GENERAL INFORMATION

Applicant:	United Properties (Owner)
Location:	5501 and 5601 American Blvd. W.
Requests:	1. Negative Declaration regarding the need for an Environmental Impact Statement (EIS) (PL2018-336); 2. Comprehensive Plan Amendment re-designating the future land use from Office to High-Density Residential. 3. Rezoning from C-4(PD) Freeway Office (Planned Development) to RM-50 Multiple-Family Residential; 4. Preliminary development plan for a two-phase residential care facility and independent senior housing building; 5. Final development plans for a four-story, 108-unit residential care facility; and 6. A conditional use permit for a four-story, 108-unit residential care facility.
Existing Land Use and Zoning:	Vacant land; zoned C-4(PD) Freeway Office (Planned Development)
Surrounding Land Use and Zoning:	North – Multi-family residential and Office; zoned C-4(PD) South – Office; zoned C-4(PD) East – Hospitality; zoned C-4(PD) West – Townhomes; zoned RO-24 Residential Office

The applicant is proposing to develop two-phase residential care and independent living senior housing facilities at 5501 and 5601 American Blvd. W., respectively. Phase 1 would be located at 5501 Am

Figure 1: Existing and Proposed Land Use Designation

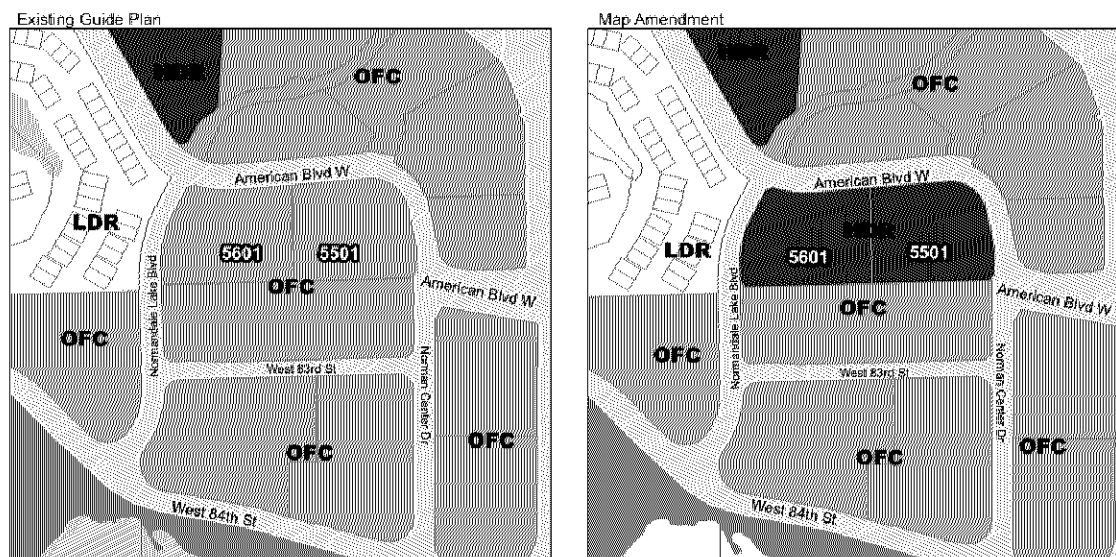
The current Office land use designation allows for residential uses, but only if integrated with a non-residential use. The proposed development is entirely residential, so it is inconsistent with the Office designation. The High-Density Residential land use designation, the proposed land use designation, would be consistent with the development. Figure 1 below depicts the current and proposed land use designation.

Figure 2: Existing and Proposed Zoning Designation

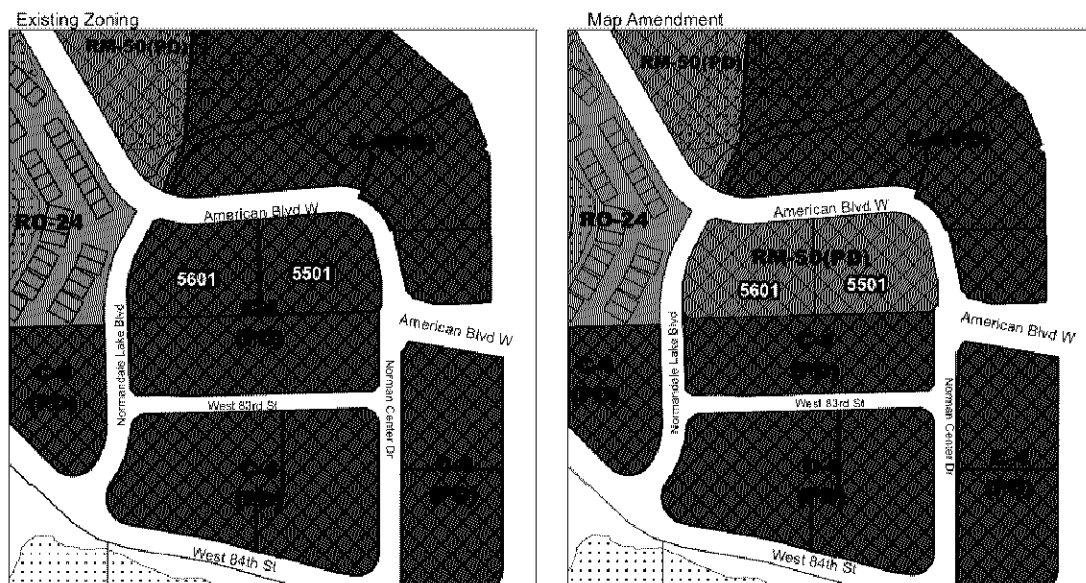
Provided the City Council approves the Comprehensive Plan Amendment re-designating the land use from Office to High-Density Residential, the proposed RM-50 would be the most appropriate zoning district. In total, the development would entail 33 units/acre, which is within the 20 to 50 dwelling unit range within the RM-50 zoning district. Figure 2 depicts the existing and proposed zoning designation.
